Island arc, Cliff Is.

AP Island Ave., Cliff Island (Assrs. 109B-C-3)

Permit to construct a stone outside chimney with fireplace on left hand side of building is being issued subject to compliance with the following:

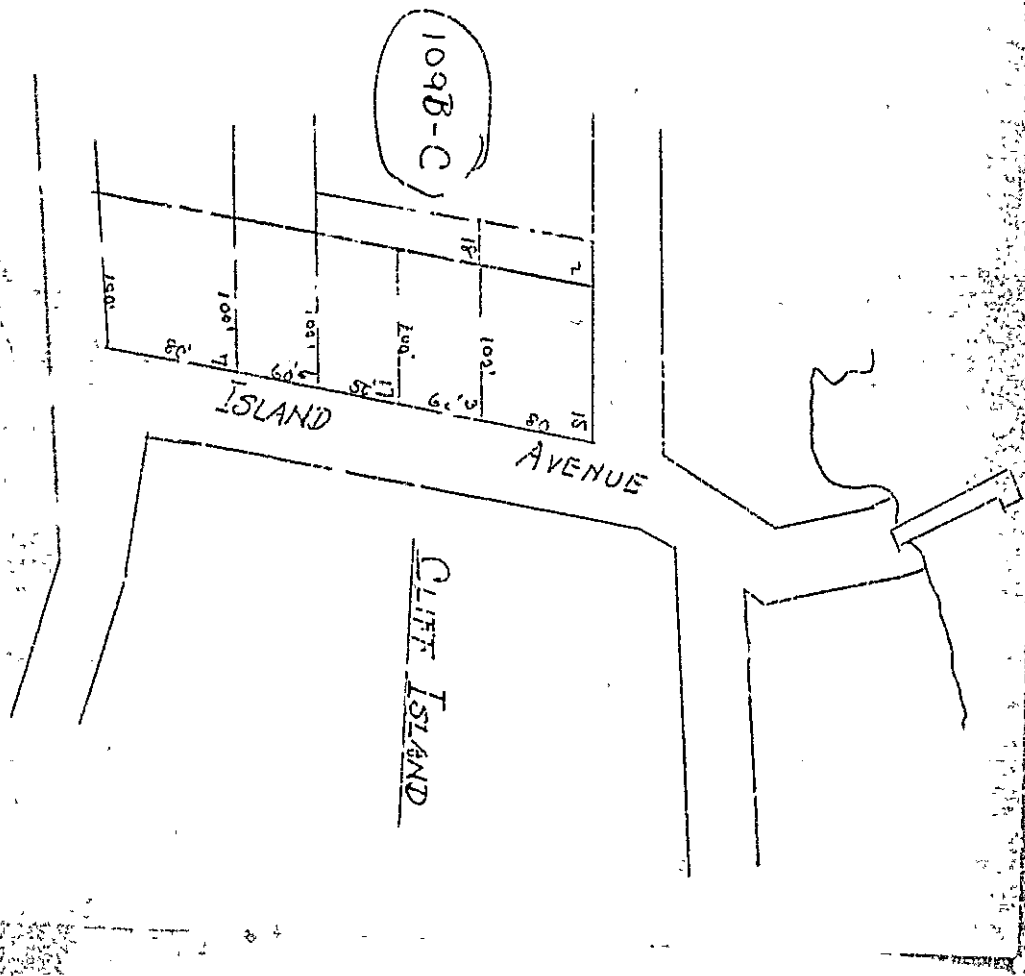
More information is needed concerning construction of a proposed addition on end of dwelling at above named location before a permit can be issued. Information needed is as follows:

1. Is there to be a cellar beneath addition? - *yes*
2. Are floor timbers to rest on top of 6x6 sills and girder or are they to be cut between and notched over 2x3 nailing strips? *yes - to use 4x8*

3. Is there to be any support at center of span of girder? If so, what is to be used for this purpose and on what is it to be supported? *no girder*
4. Are there to be any partitions in addition? If so, where are they to be located? - *no*

5. What is rise, span and spacing of ceiling timbers to be and how are they to be supported at center of span? *2x6 - 24" - 7' hung to ridge*
6. Is roof of addition to be a continuation of roof of main building or is it to be lower? Is space above ceiling to be used? - *yes - no*

7. What is pitch of roof to be? - *8"*
8. What is number and size of windows in addition to be? *double headers*
9. Is there to be any opening between existing building and addition? - *door opening* *jack studs*

ISLAND AVENUE, CLIFF ISLAND

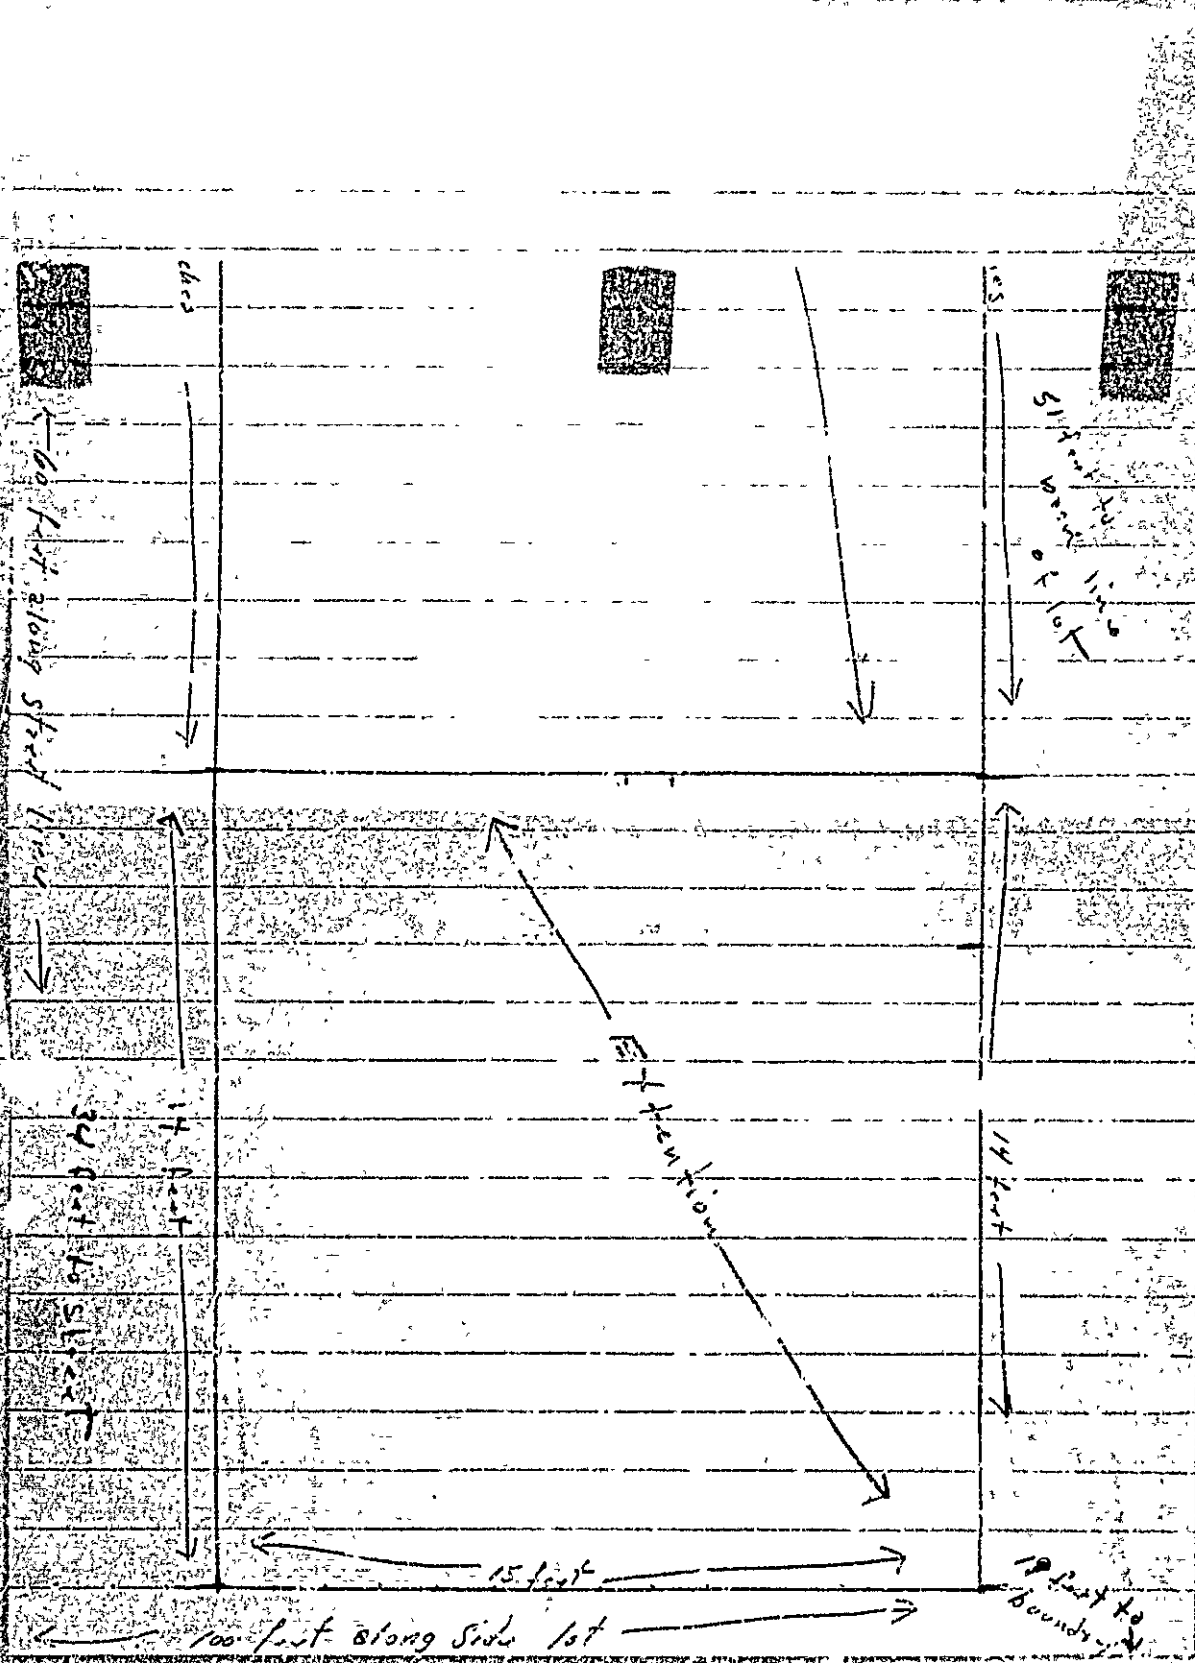
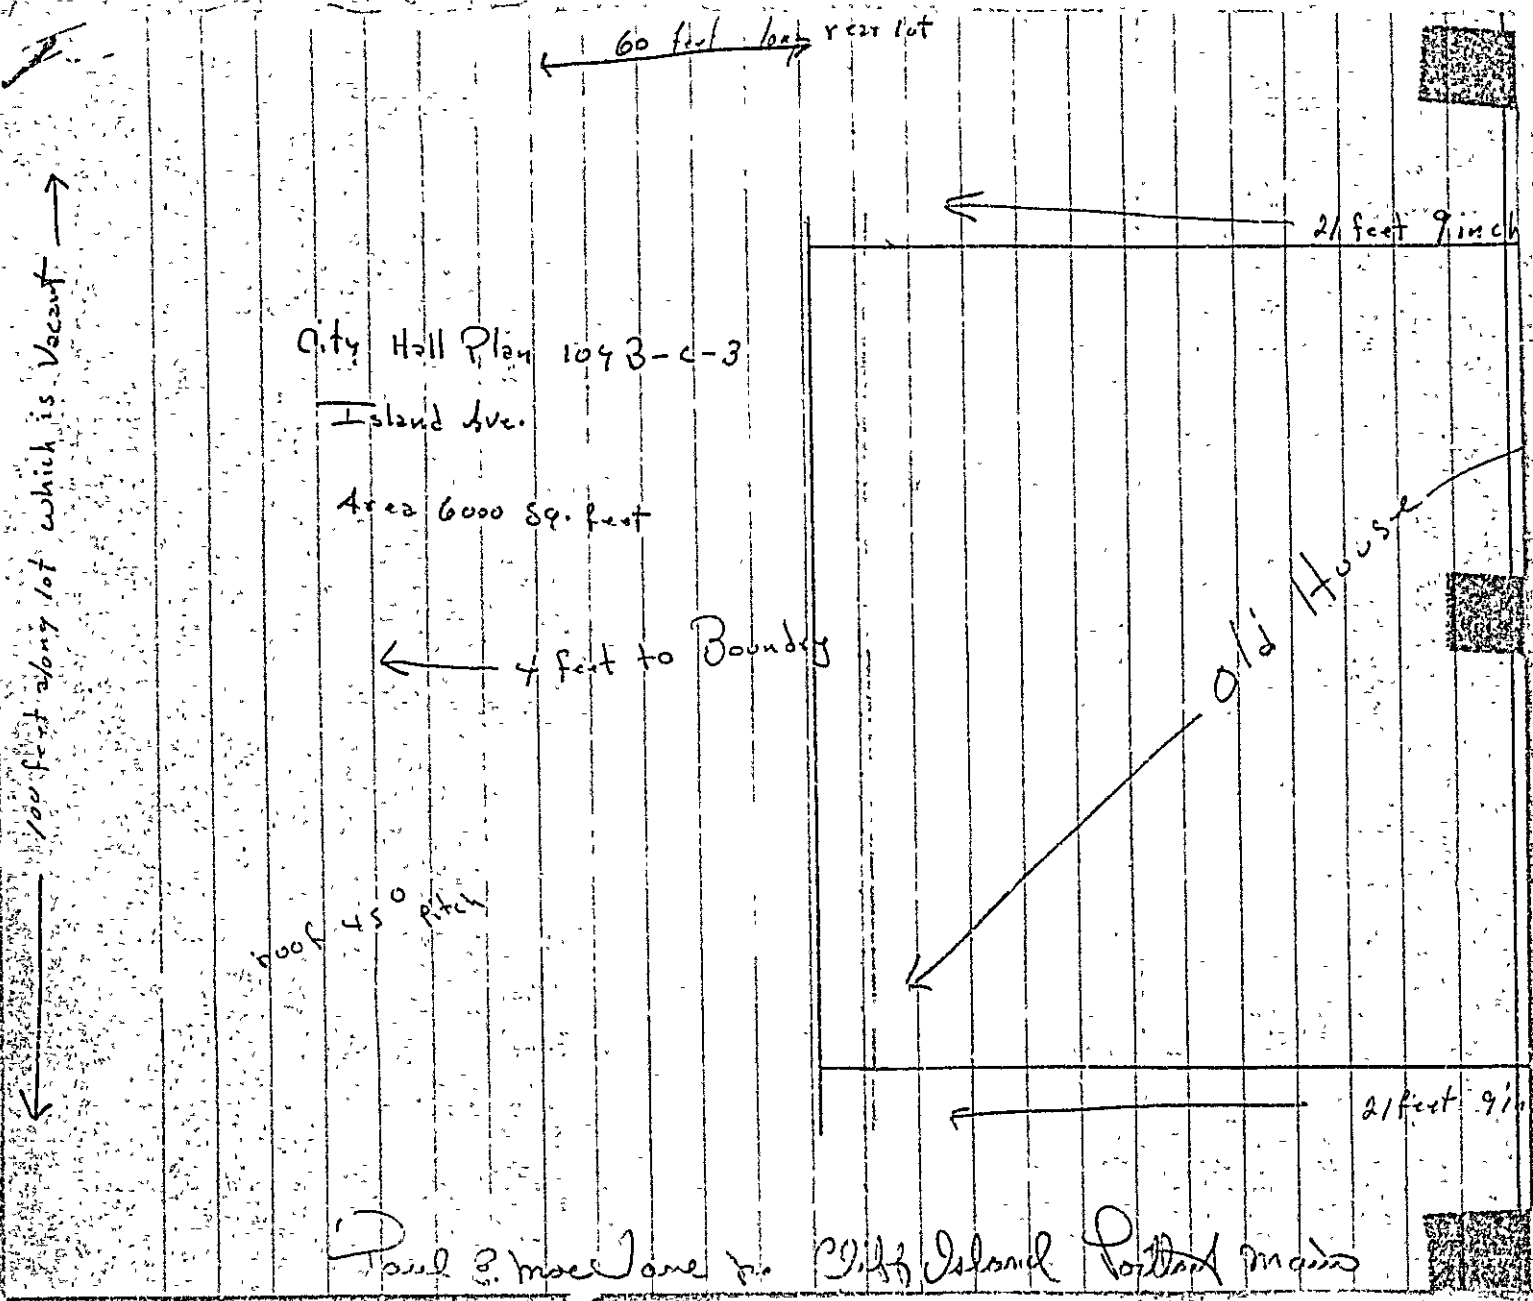
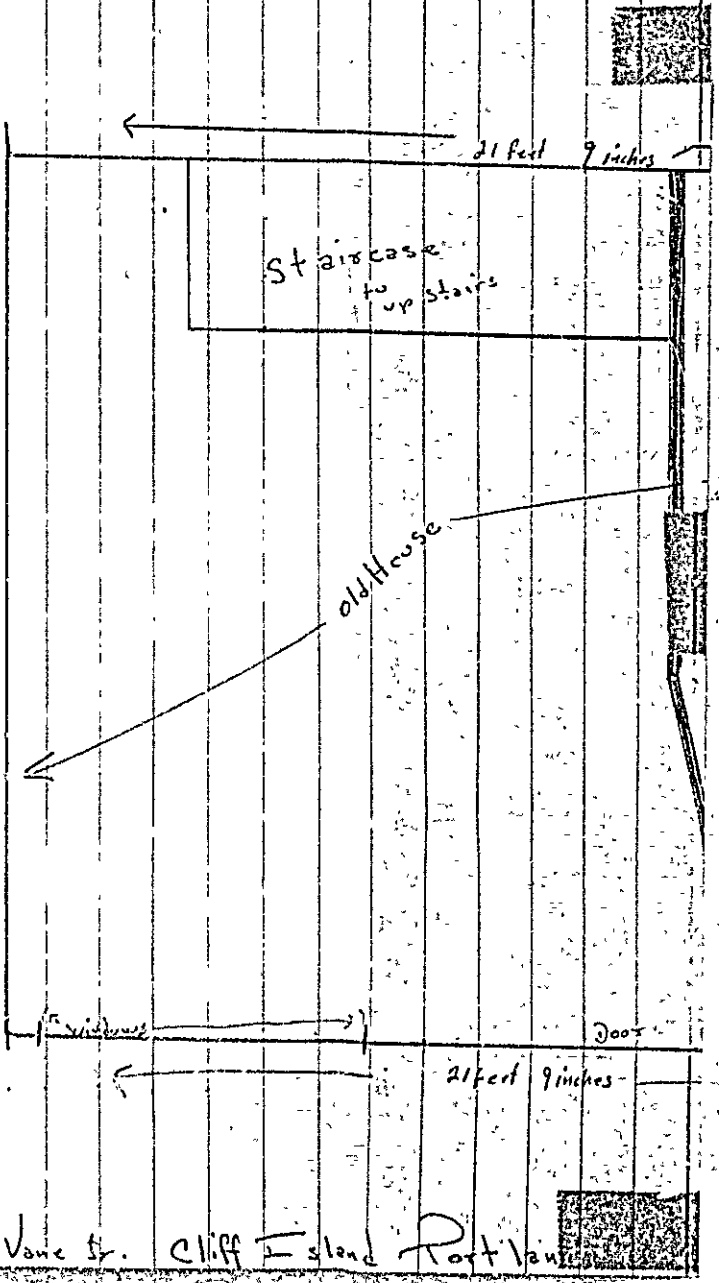
7 feet to Boundary

7 feet to Boundary
